Planning permit no. PA2504094, 52-58 Pipe Road, Laverton North

Officer Assessment Report
Development Approvals & Design

Department
of Transport
and Planning

Figure 6 Swept path diagrams showing truck movements using both sides of the proposed vehicle crossing to Raymond Road for access and egress

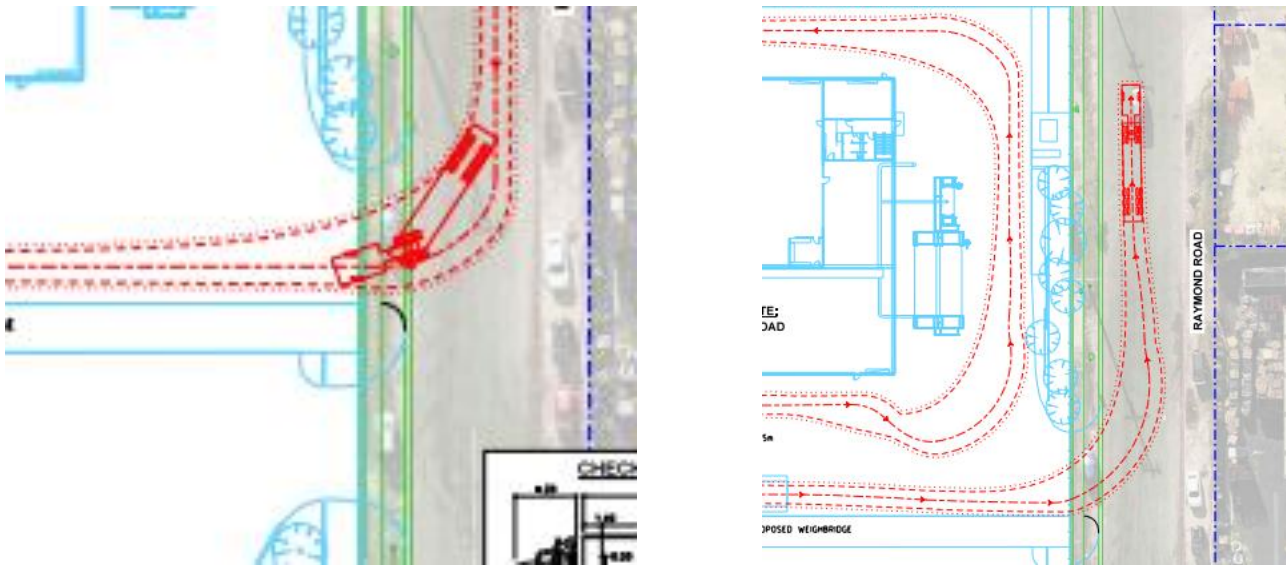
Council has objected to using the proposed vehicle crossing for both access and egress, noting the swept path diagrams show a conflict would occur when two trucks are exiting and entering at the same time. It is acknowledged the applicant's traffic engineer has stated the probability of two vehicles needing to use the vehicle crossing, or queuing in Raymond Road, is unlikely. No thorough assessment, however, has been provided to support this view.

58. Council has recommended access and egress be separated to resolve the issue, involving one or more of the following options:

- Use of the proposed vehicle crossing for entry only and the existing Truck Wash crossover to exit.
- Separate vehicle crossings for the site.
- A fixed physical barrier may be installed to clearly define vehicle paths.

Figure 7 Swept path diagram showing truck movement using existing truck wash vehicle crossing for egress

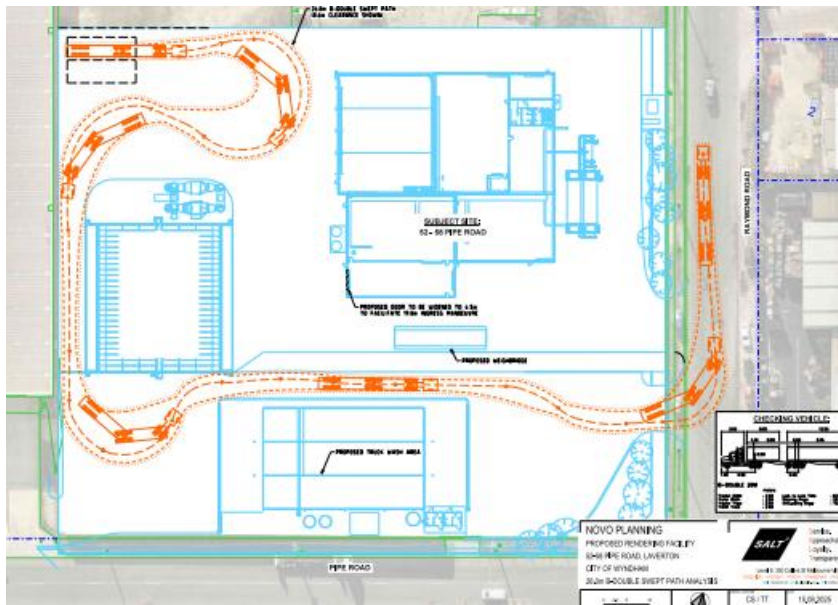
59. It is noted the swept path diagrams show the truck wash vehicle crossing being used for larger B-double trucks.
